Package Outline Drawing Update for Intersil HPBGA Packaged Products

**Refer to:
PCN10113**

Subject: **Package Outline Drawing Update for Intersil HPBGA Packaged Products**

V356.27x27C

New POD – PCN10113

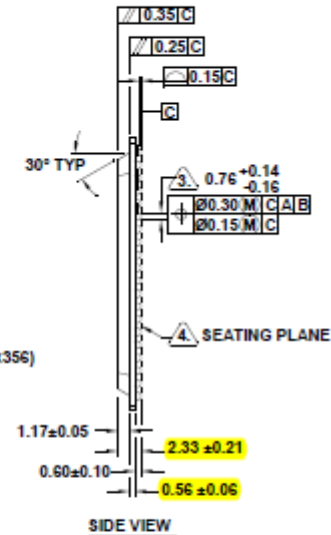
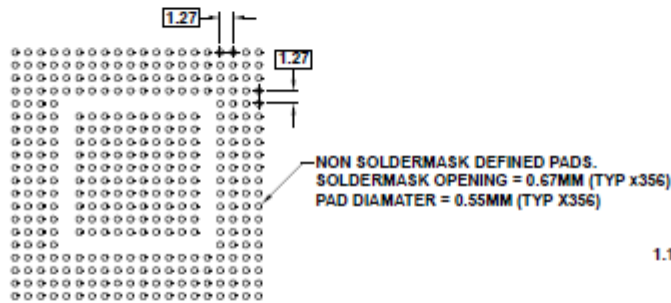
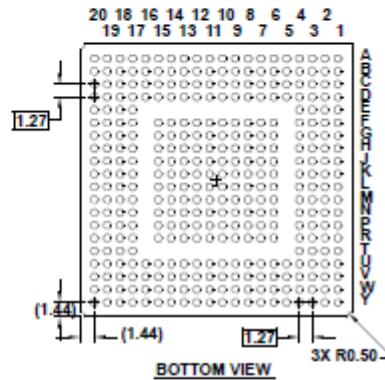
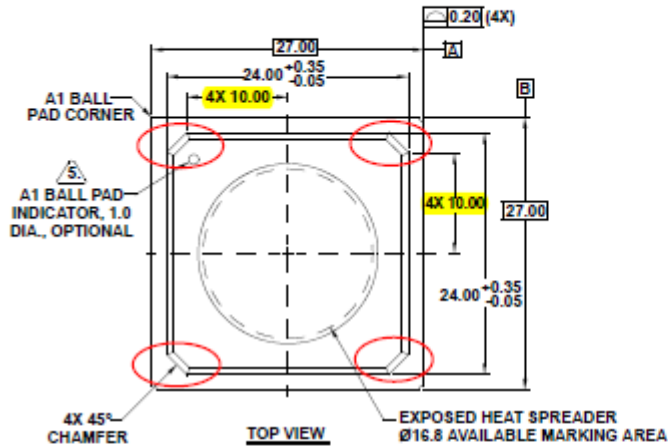
This notice is to inform you that Intersil has updated the POD (Package Outline Drawing) for the listed HPBGA (Heatsink Plastic Ball Grid Array) packaged products. The POD updates are the result of an upgrade in the tooling used in the assembly operations and affect the corner chamfer dimensions of the lid and the thickness of the package base/body. The current and new PODs with the changes identified are included for reference. Both the current and new PODs conform to JEDEC outline MS-034/A variation BAL-2. Revisions to the data sheet specifications incorporating the POD updates are in progress and will be available on the Intersil web site upon release.
